SED Incident Investigation Report for 2018 Camp Fire with Attachments

Incident Investigation Report

Incident Number: E20181108-01

Utility Facilities involved: Caribou-Palermo 115 kV Transmission Line and Big Bend 1101 12 kV Distribution Circuit

Figure 2. At Tower :27/221, an insulator hold-down anchor was disconnected. Photo provided by PG&E.⁷⁸

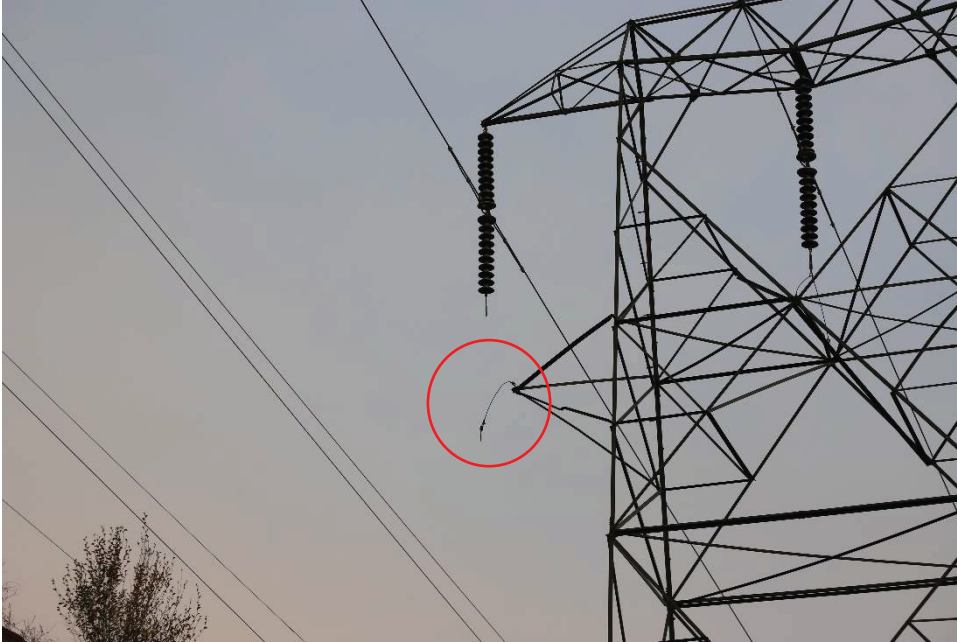
At first, SED made observations at Tower :27/221, adjacent to the Incident Tower. The distance between the two towers is approximately 845 feet.²⁷ SED observed that the hold-down anchor on Tower :27/221 had disconnected from the suspension insulator. This is shown in Figure 2.

Tower :27/221 had disconnected from a suspension insulator. PG&E assigned the condition a Priority Code E.⁴⁸ As defined in the ETPM Manual, the Priority E designation is for conditions which must receive corrective action within 12 months. SED notes that during additional enhanced inspections that PG&E performed after the Camp Fire, PG&E assigned a Priority A code for a separate broken hold-down insulator hardware on a different tower on the Caribou-Palermo Transmission line.⁴⁹ According to a PG&E lineman who was at the site on November 14, 2018 the hold-down anchor on Tower :27/221 was not broken, but rather had become unscrewed. Nevertheless, the hazardous condition created by an unscrewed hold-down anchor is similar to that created by a broken hold-down anchor. SED concludes that the unscrewed insulator hold-down anchor on Tower :27/221 should have been designated Priority A. This is a violation of GO 95, Rule 18.

Figure 8. Typical location of runner arms on transmission towers similar to the Incident Tower. This is PG&E Tower :20/160 of the Caribou-Palermo 115 kV Transmission Line.⁸⁴

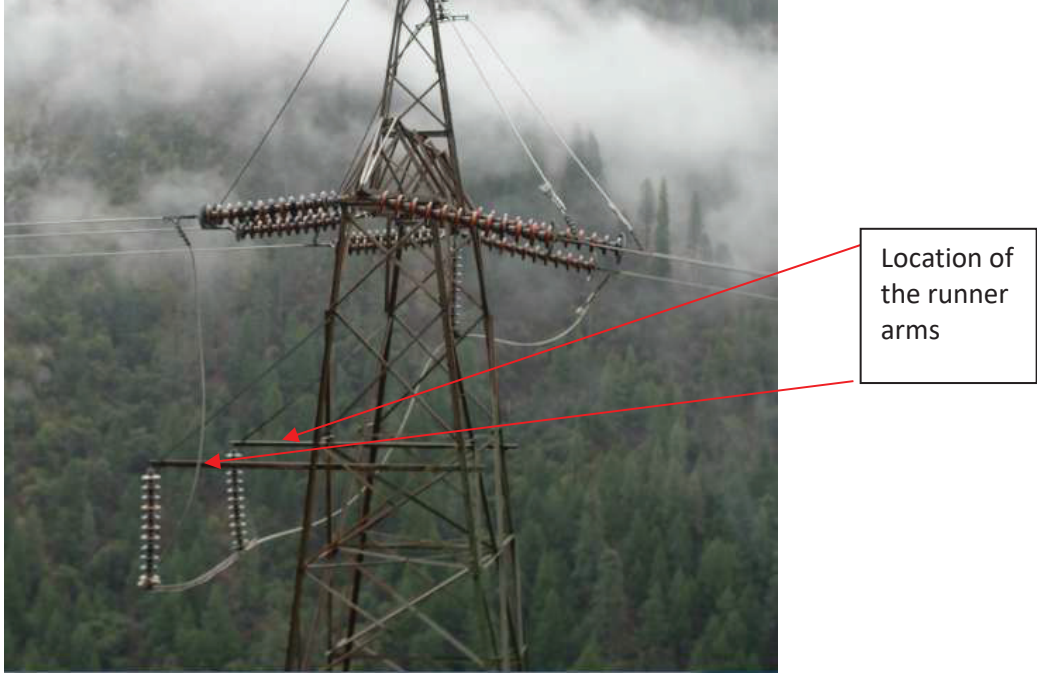
elongated holes in Figure 6 and Figure 7. For reference, Figure 8 shows a typical location of runner arms on transmission towers that have them.
